**RE: Request for Site Plan Approval at 1 Congress Street, Proposed Site Development**

This submission is intended to address comments from the TAC Meeting of November 1, 2022. The project had been submitted as a site plan application which included some developer proposed off-site improvements to adjacent city streets. During the TAC Meeting part of the discussion was a desire to bifurcate the application into two parts: the Site Plan Approval and the Off-Site Improvements. Since the Off-Site Improvements are proposed on public property (city streets) it was determined that permitting that part of the proposed development would be best accomplished as a separate process. This submission, therefore, will only address those comments from the TAC Committee that pertain to the Site Plan approval. The specific comments, with response in bold text, are repeated below:

## 1 CONGRESS STREET PORTSMOUTH, NEW HAMPSHIRE SITE PERMIT PLANS

PB.A7

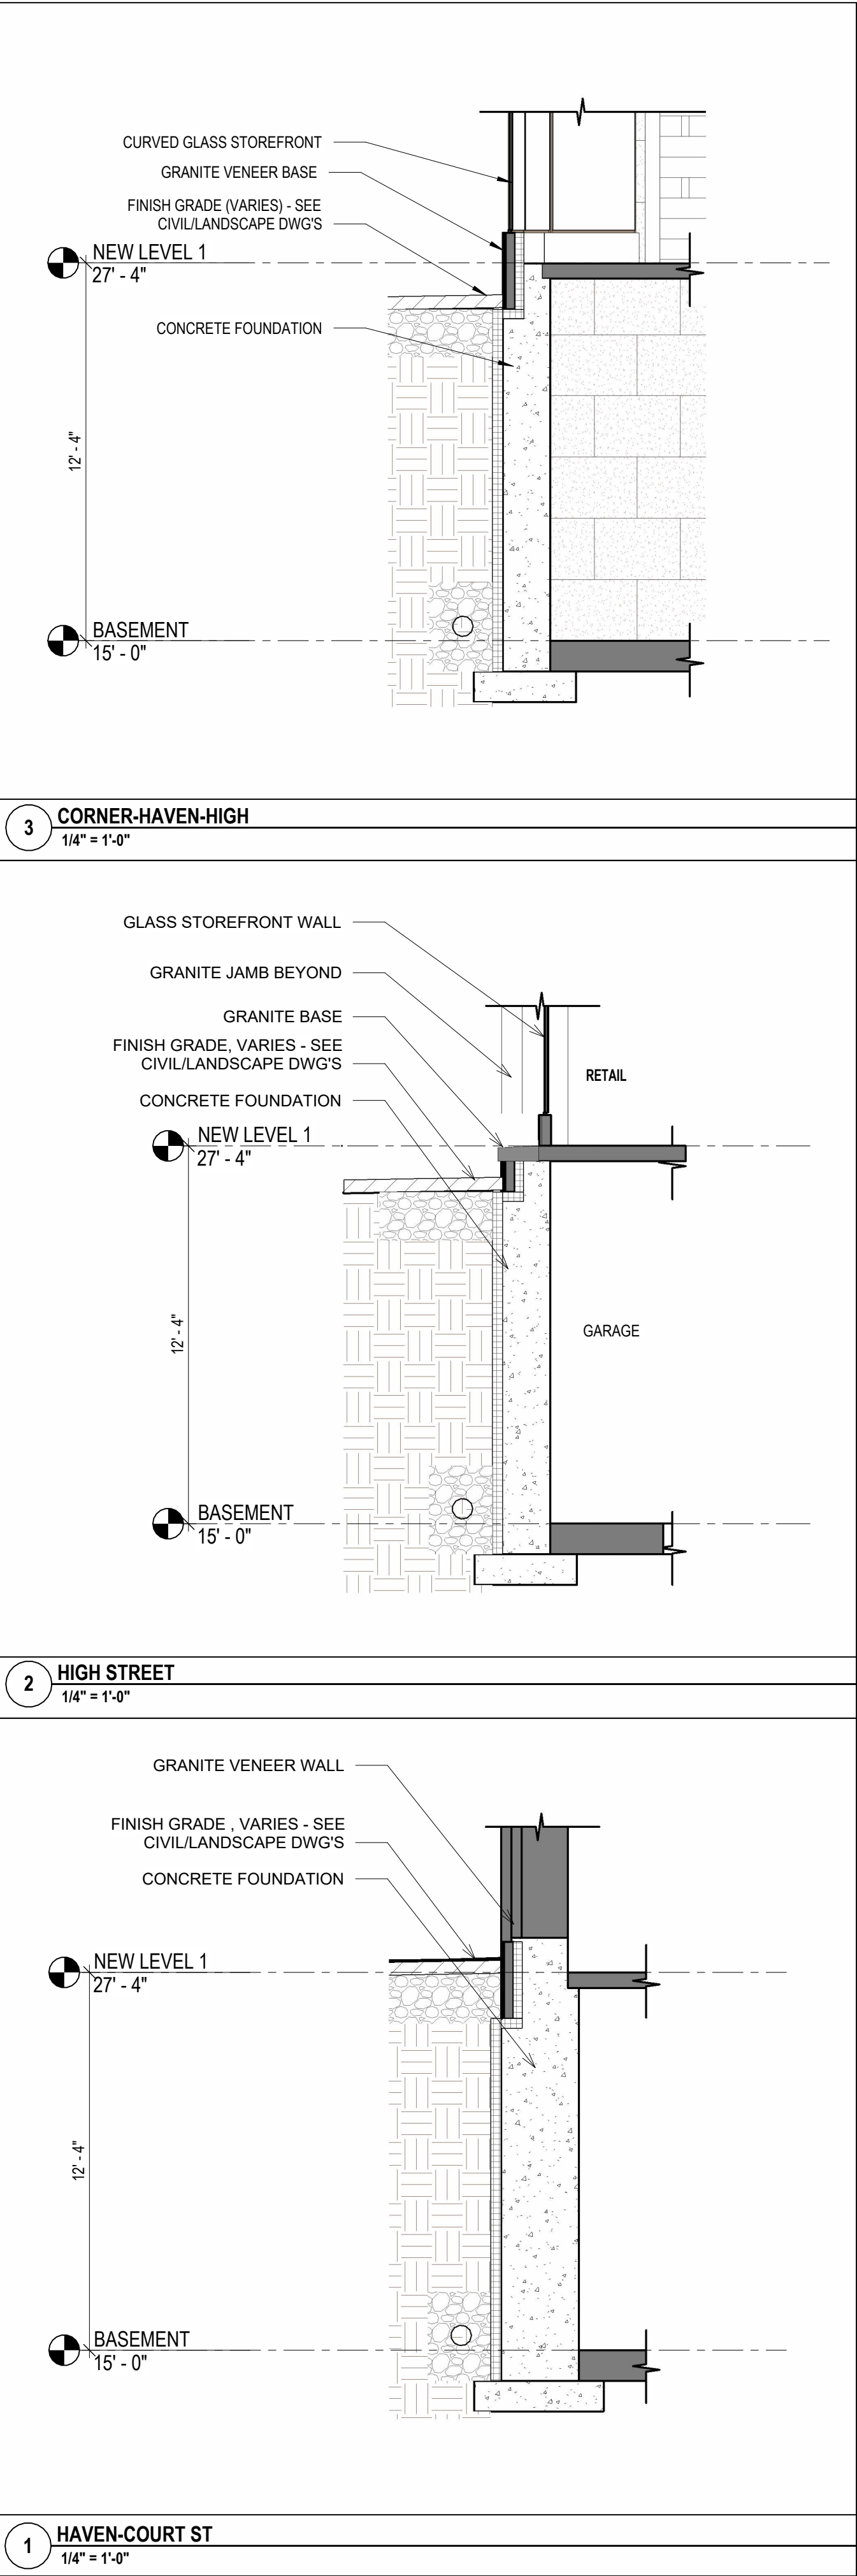
28. Provide cross sections of foundation system depths in proximity to High Street. **The detail is on Sheet PB A. 8 of the Architectural plans.**
29. All materials used in Reconstructing public areas will meet DES / DOT / City standards and will need to be reviewed and approved prior to use. **Those improvements are no longer a part of this application.**

UTILITY PLAN

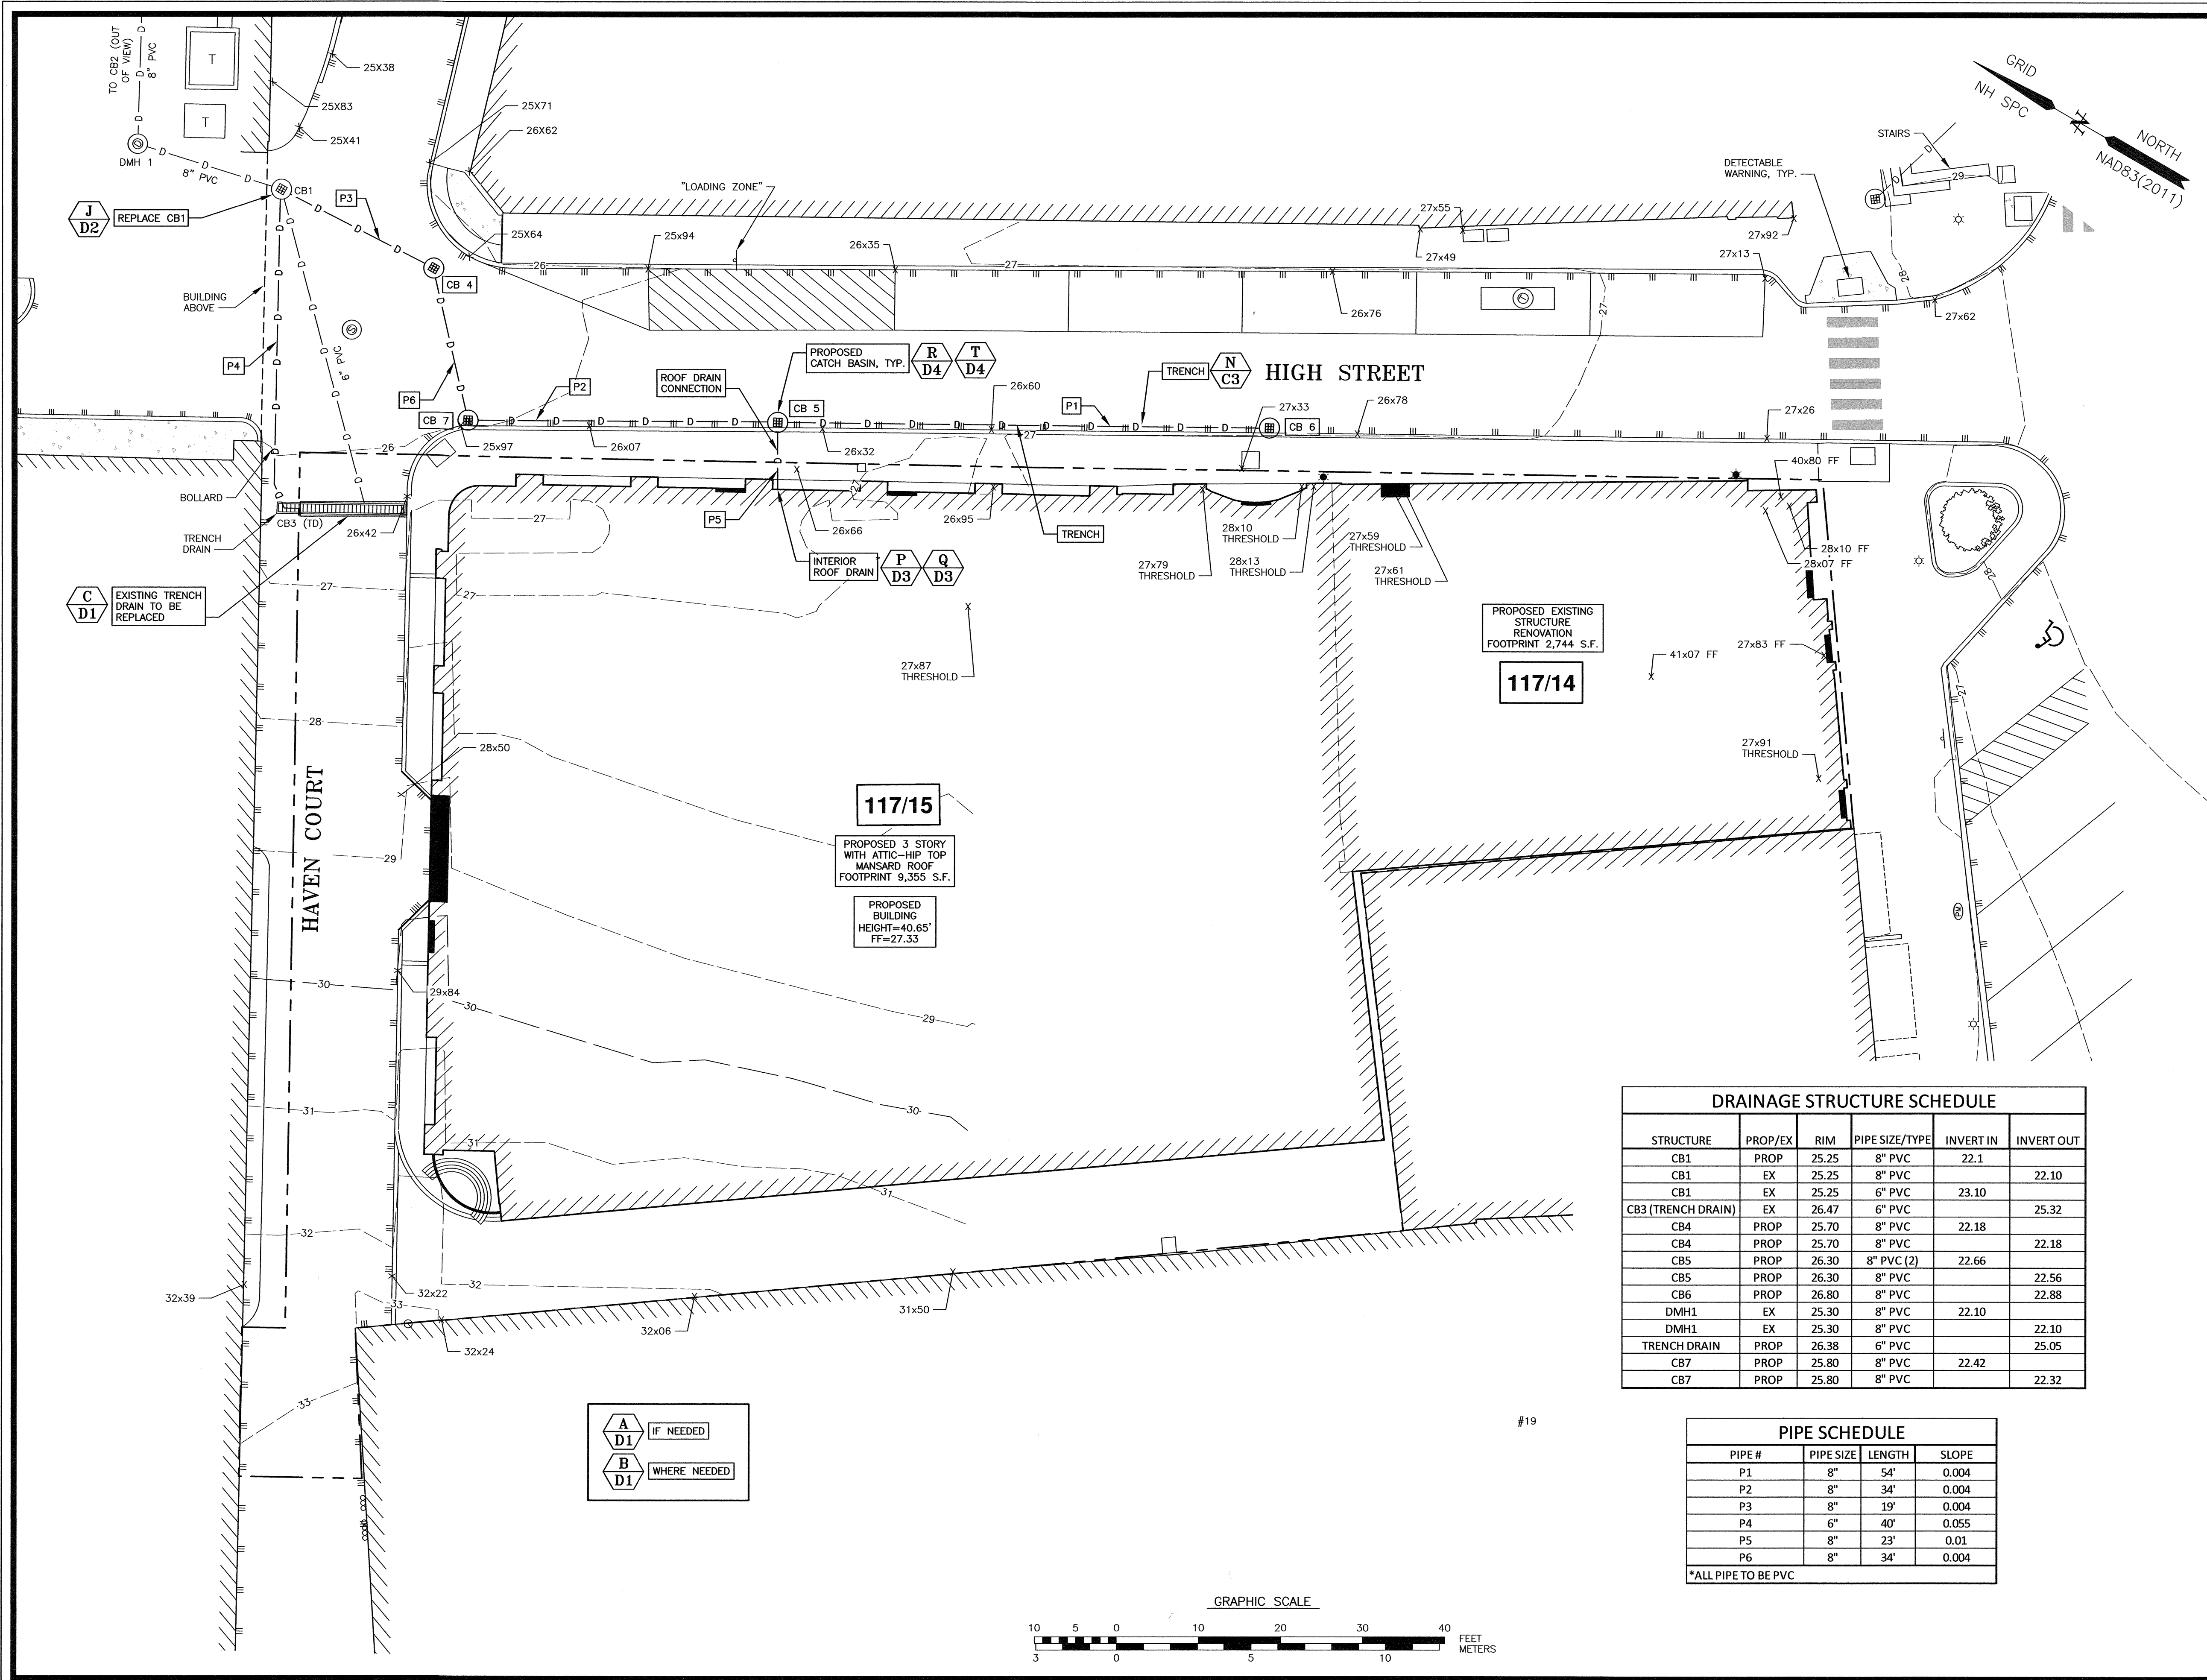
10. Replace SMH 2323. **So noted on Sheet C4.**
11. Replace existing sewer with 8" PVC or 12" depending on projected flow, provide separate sheet for State approval with Profile. Proximity to water main will necessitate a waiver from DES. **See added Sheet P1.**

12. Proposed SMH 'A' should be placed just upstream of the first sewer service. **Revised – see Sheet C4.**
13. Applicant should consider running storm drainage on the other side of High Street due to existing utility conflicts, relocating the gas main to under the sidewalks is preferable to the disturbing the telephone lines. **Drainage revised to be an added feature to the existing street. Basins proposed to be added at the existing curb line on the south / west side. No gas relocation proposed. The brick sidewalk on that side of the street will be re-constructed.**

14. Water main to be replaced with 8" ductile iron from the 12" pipe in Congress Street to the 4" line in Ladd Street. Do not reuse valves, tap main in Congress directly with new 12 x 8 tapping saddle and valve and abandon 6" system at 12" main. Provide 8" valve at intersection of Ladd and High to test against and tie into 4" thereafter directly (no tapping saddle). Provide temporary water for adjacent buildings during main installation. **Revised – see location and notes on Sheet C4.**

20. Provide clear intended limits of work lines on plans for review. **See location and notes on Sheet C4.**
21. Use Portsmouth Standard water and sewer installation details. **See supplied Portsmouth standards sheet for sewer. Water details await confirmation of layout.**

30. Replacement of CB1 may be required due to different pipe configurations. **So noted on Sheet C4.**
31. Confirm High Street slopes will not exceed ADA required maximum cross slopes. **The current plan is to replace the existing sidewalk.**

D4

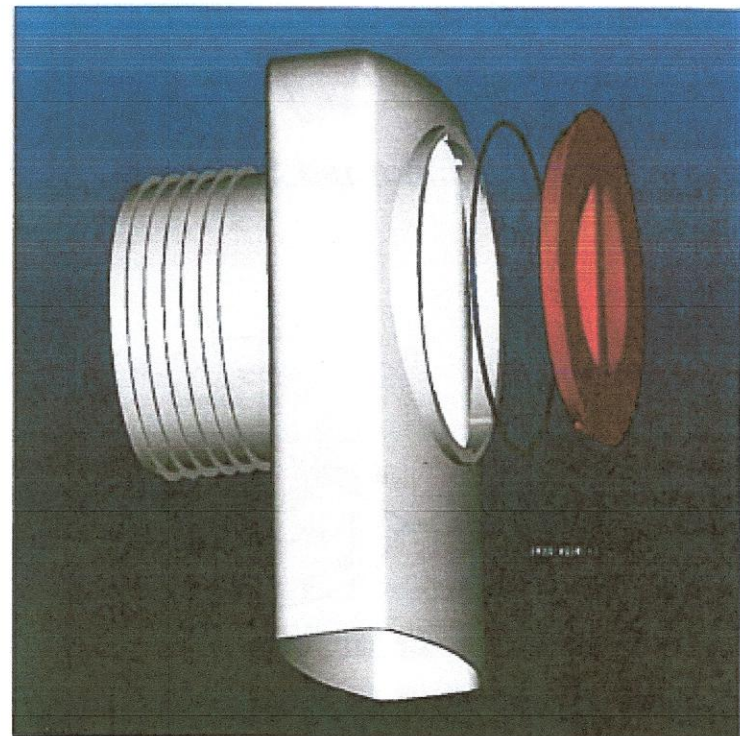
16. Use NHDOT standard catch basin Type B detail with CB liner/ booted connections etc. **See Detail R on Sheet D4.**
17. CB hoods to be Eliminator, City Standard on all structures in ROW. **See Detail T on Sheet D4.**

18. Provide valve box sleeve and cover over all Hayes style curb boxes in ROW. Hayes boxes are no longer accepted as a finished surface in the road or sidewalks. **See Detail V on Sheet D4.**
